Crown Castle
3530 Toringdon Way Suite 300
Charlotte NC 28277

Jerry Feathers
Tel (704) 405-6549
Fax (724) 416-6484
Email: Jerry.feathers.contractor@crowncastle.com

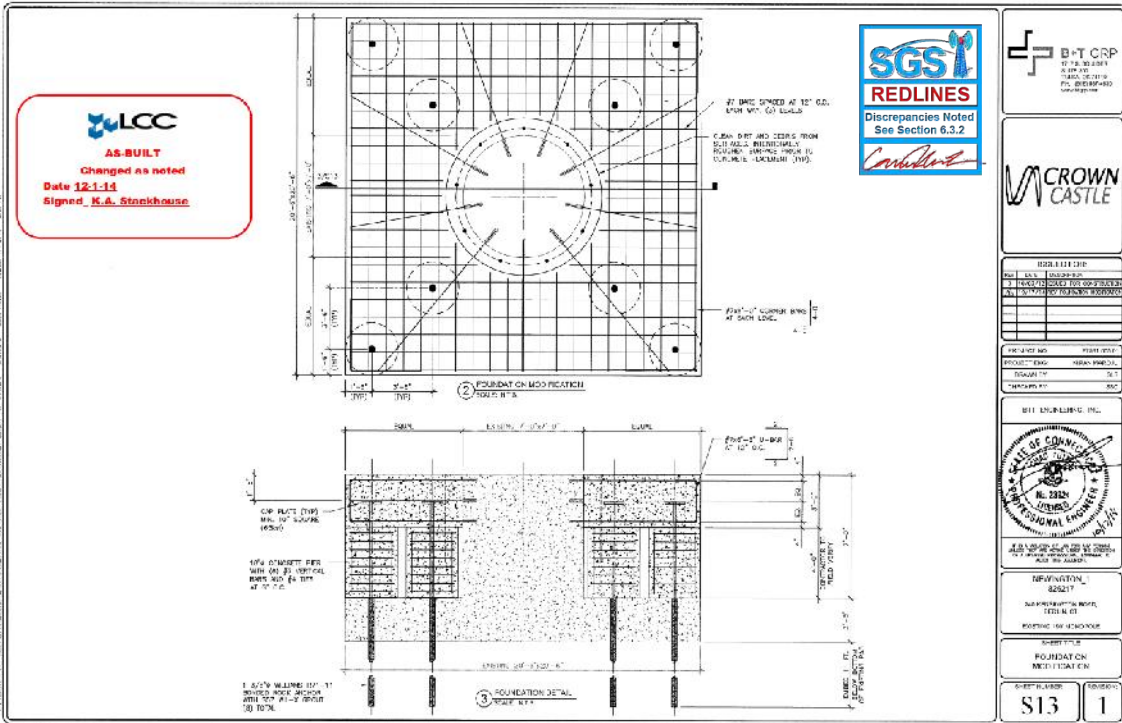
SGS
REDLINES
 Discrepancies Noted
 See Section 6.3.2
Combs
